2 ARCHITECTURAL ADDENDUM

3 MECHANICAL ADDENDUM

**The following changes/clarifications in the tender documents are effective immediately.
This addendum will form part of the contract documents.**

PACIFIC AGRI-FOOD
RESEARCH CENTRE
MECH & ELEC RETROFIT

COOLING TOWER
SITE PLAN

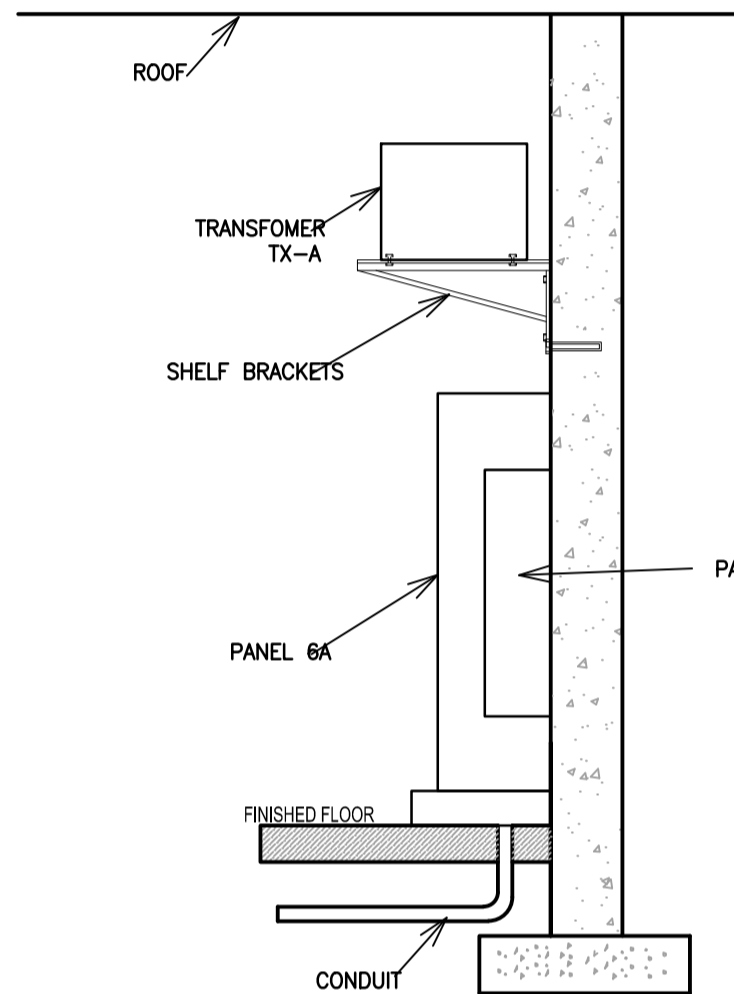
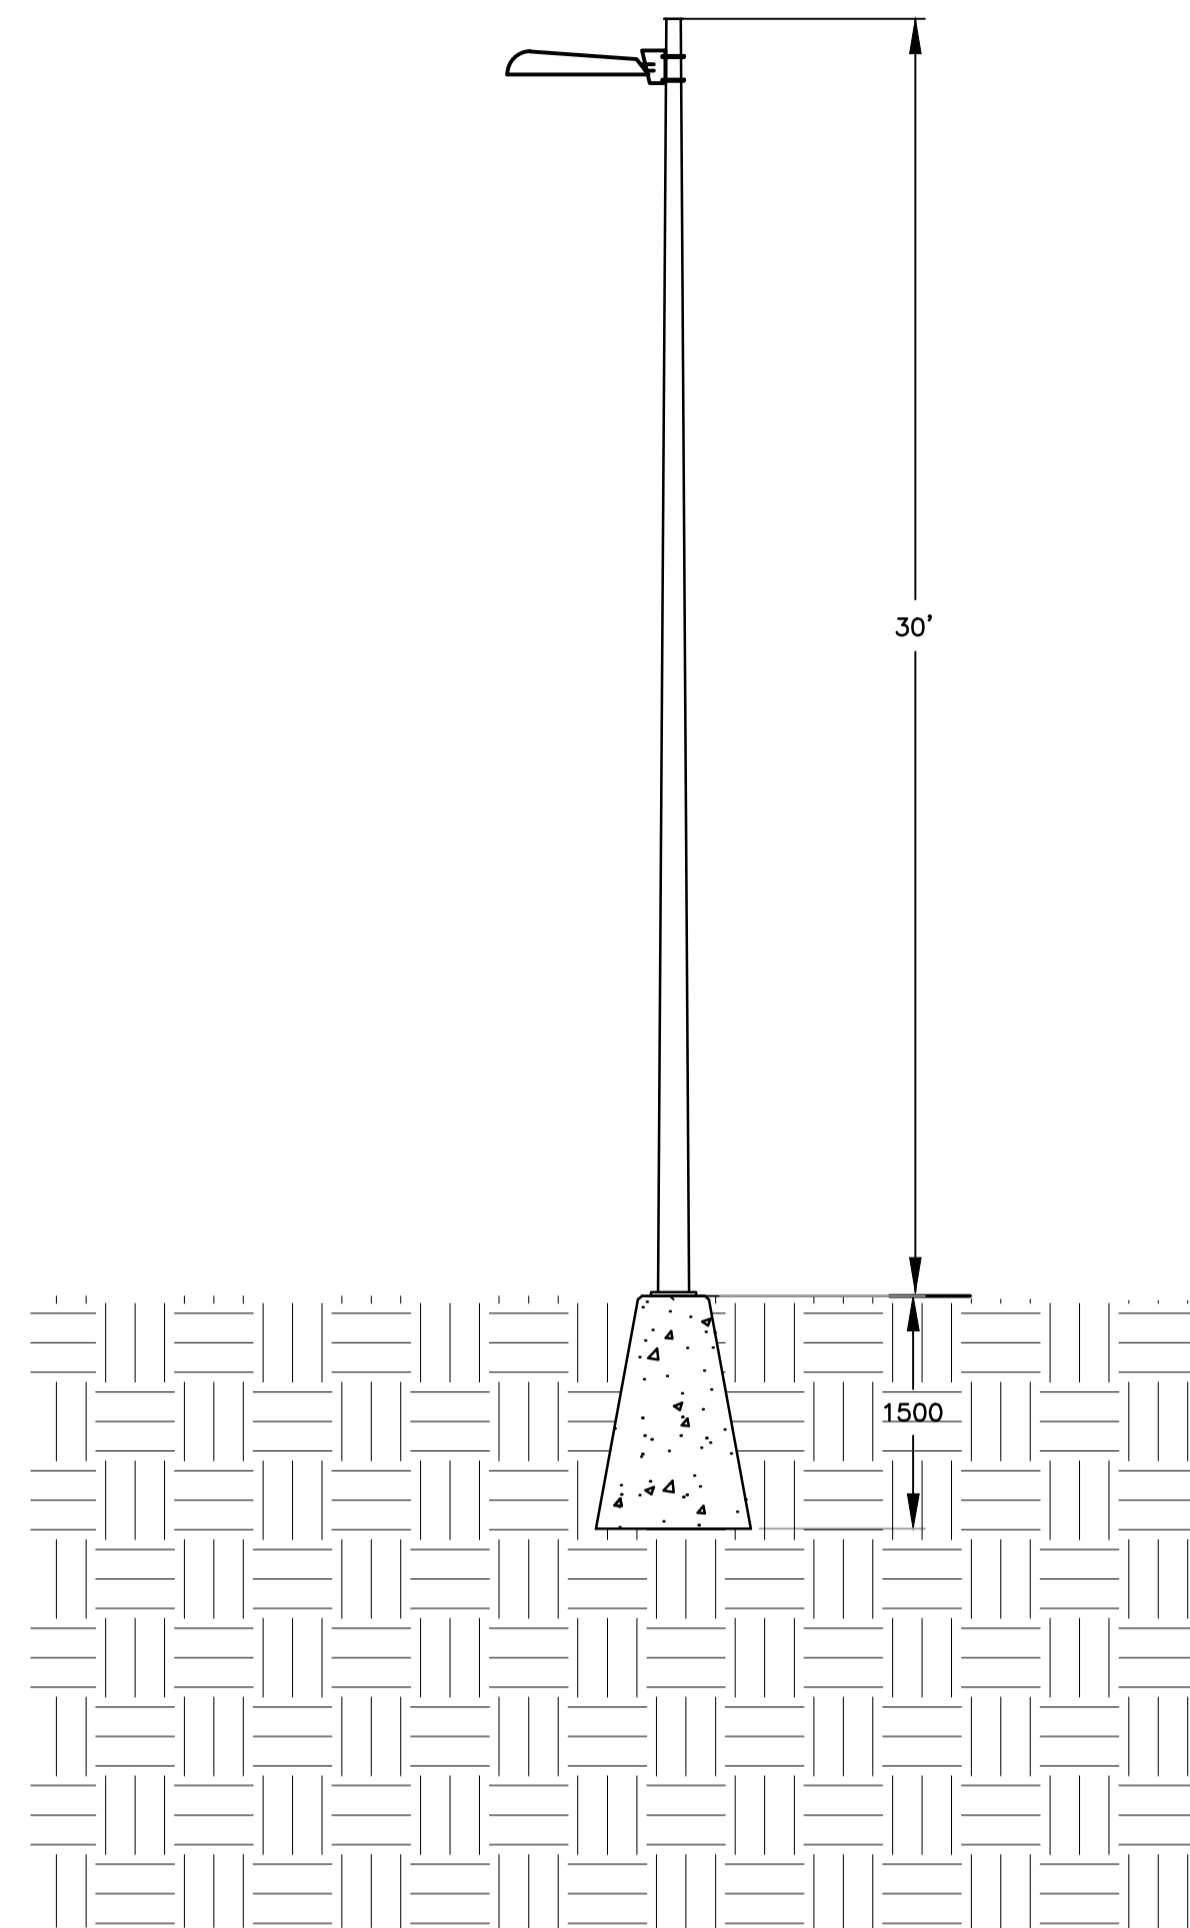
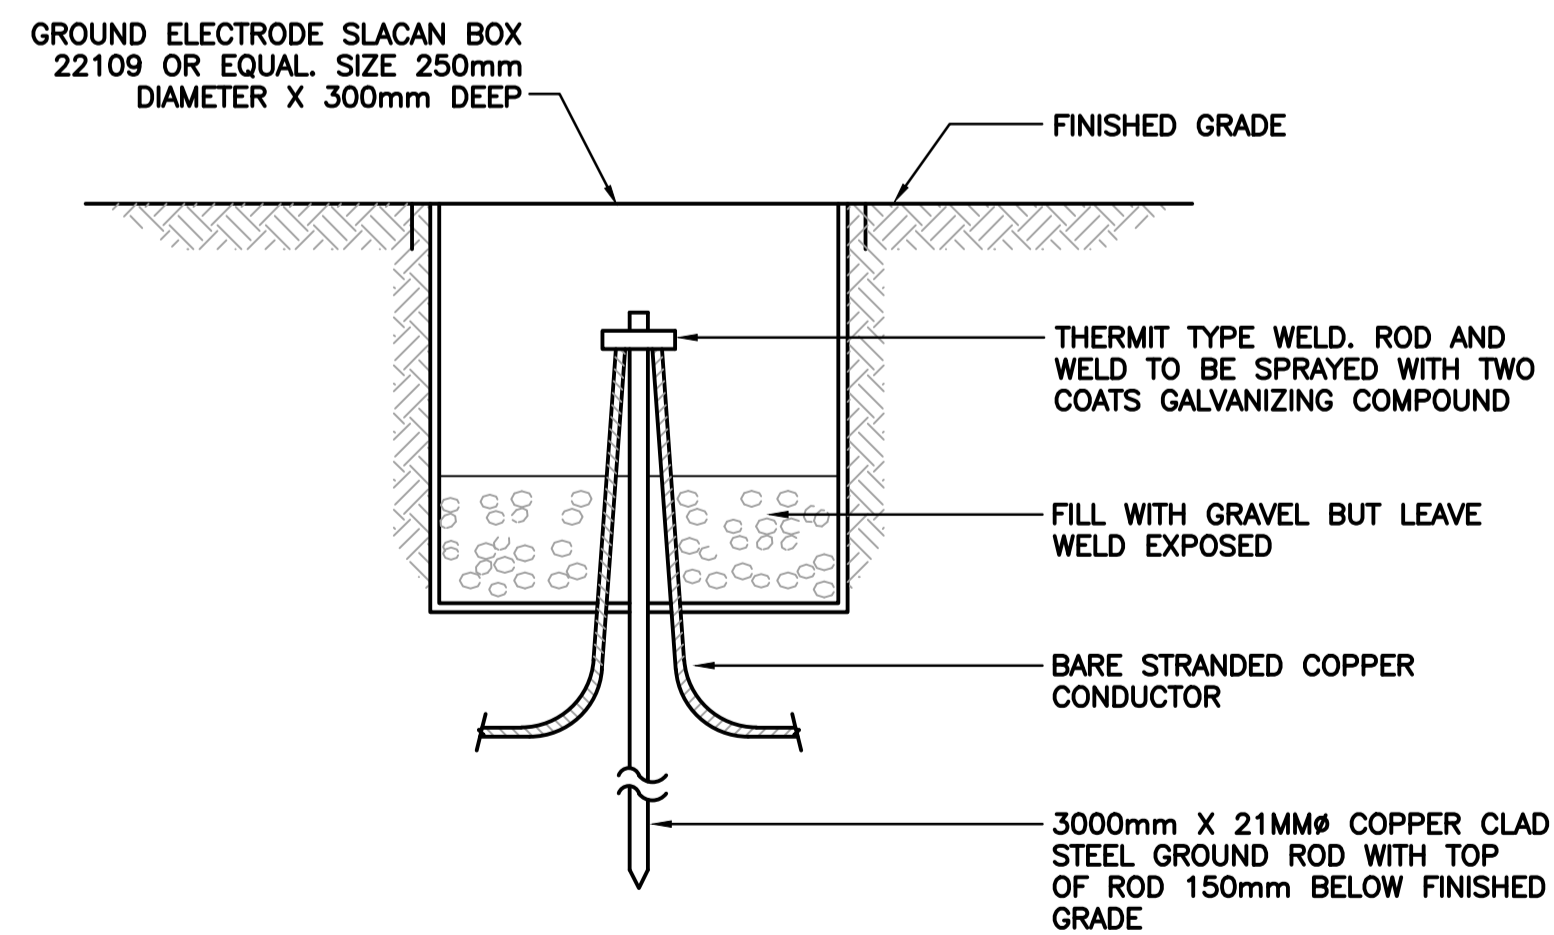
- .2 Add drawing scale and scale bar.
- .4 Drawing E-810
 - .1 Move JB 332 and JB T266 to outside the fence in the landscape area and to match new conduit trench path.

- .2 Move pump, fans, cables, controller, connections, and junction box for CT2 from current CT2 location to new CT2 location.
 - .3 Move controller for CT1 to new location.

- .4 Extend power and communication conduits for CT1, CT2, and future CT3 to match new controller locations.
 - .5 Add drawing scales and scale bar.
- .5 Drawing E-820

- .7 Q7: Poles shown on drawing E-810 for the 2 pole lights have 2 different sizes? Which is correct 20' or 30'.
A7: Light pole is 30' High.
- .8 Q8: Are we including a seismic engineer like the spec or is the bid depository exclusion superseding?
A8: Seismic engineer need to provide seismic schedule.
